## **DART SERVICE INSTRUCTION**

**TO AMEND INSTALLATION INSTRUCTIONS IIN-D350-689 REV. A  
AND FLIGHT MANUAL SUPPLEMENT FMS-D350-689 REV. A**  
REF. CANADIAN STC: SH02-33  
REF. FAA STC: SR01620NY

The purpose of the **DSI 9269-011** Floor Provision Modification Kit is to modify the D350-689-013 Floor Provision Kit to allow the dual high back seat to be installed 3" further aft.

**FIGURE 1**

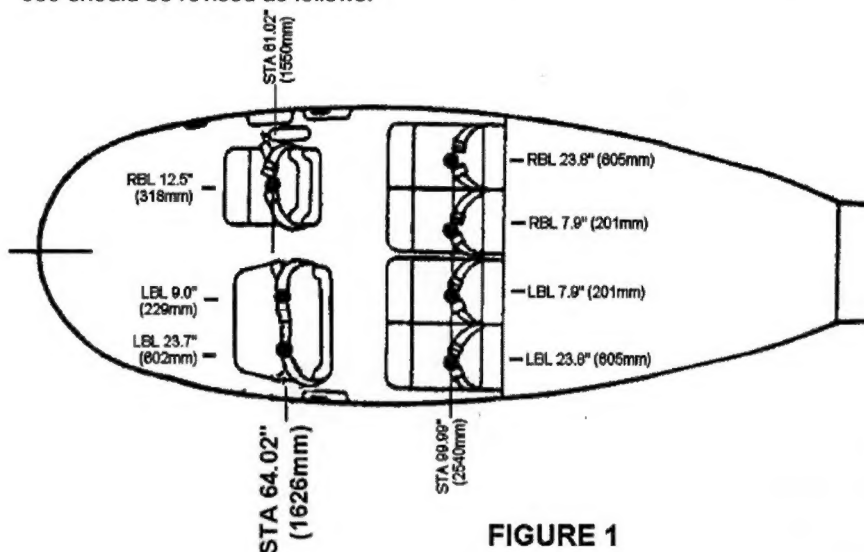
For Dual High Back Seat Installations moved 3" aft per the DSI 9269-011 kit, the loading chart given in FMS-D350-689 should be revised as follows:

FIGURE 2

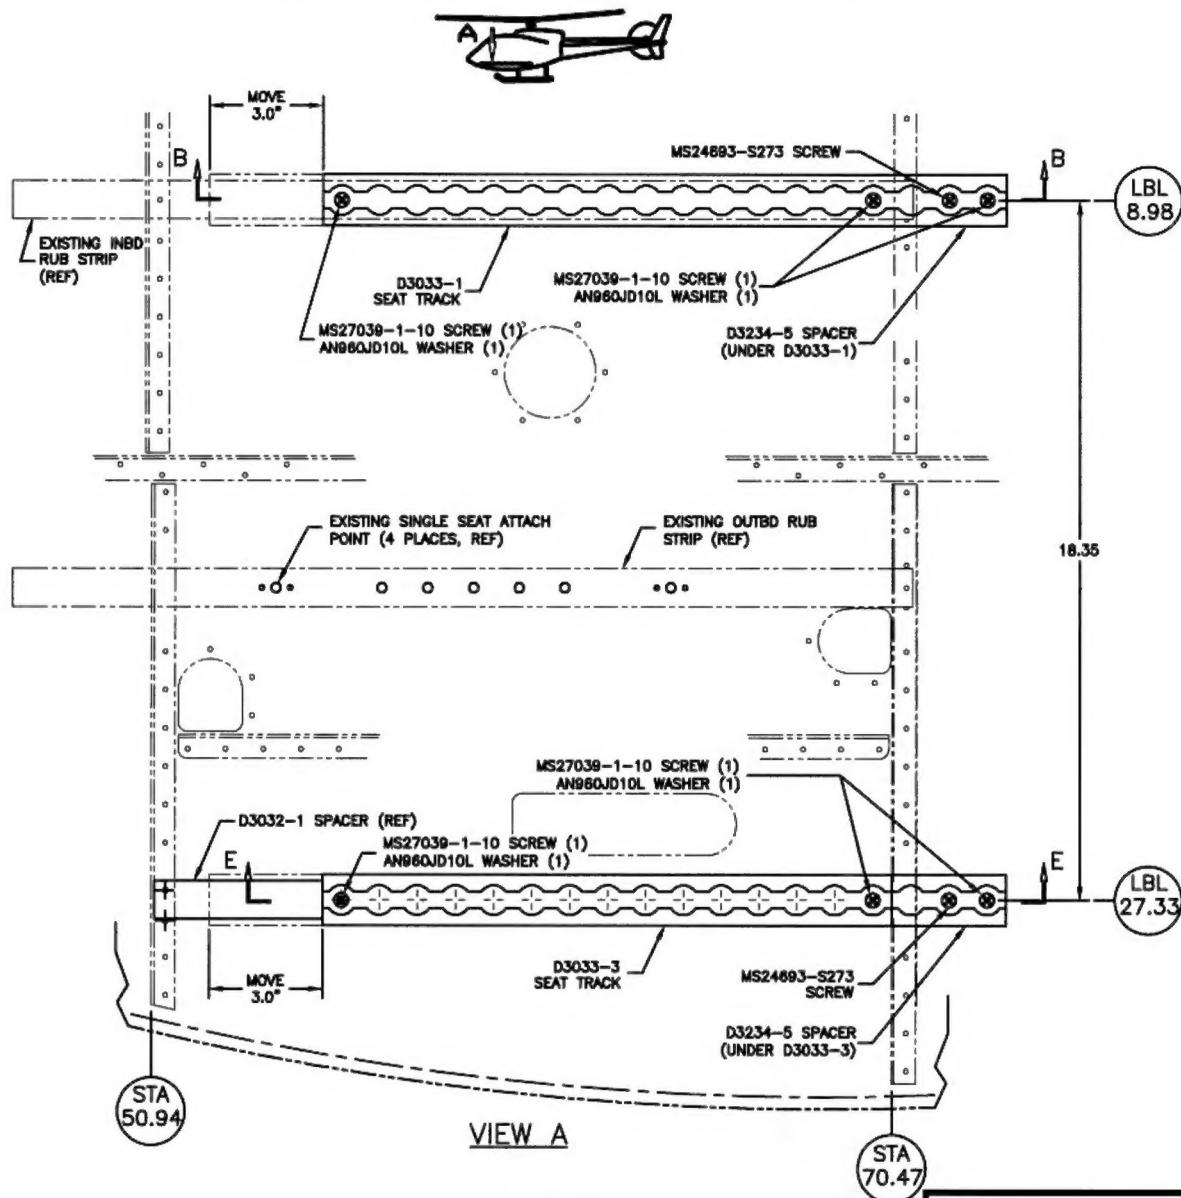
- 1) Remove existing D3033-1 and D3033-3 Seat Tracks.
- 2) Install D3234-5 Spacers as shown in Figure 2 using MS20426AD4 rivets.
- 3) Locate D3033-1/-3 Seat Tracks 3" further aft as shown in Figure 2. Transfer new screw locations to floor and install MS21059L3 nut plate at these locations using MS20426AD3 rivets. Install D3033-1/-3 Seat Tracks with hardware shown in Figure 2. Fill unused holes with hardware.
- 4) Rivet D3234-1 Doubler to D3025-1 Beam and D3234-3 Doubler to D3026-1 Beam as shown in Figure 3 using MS20426AD4 rivets.
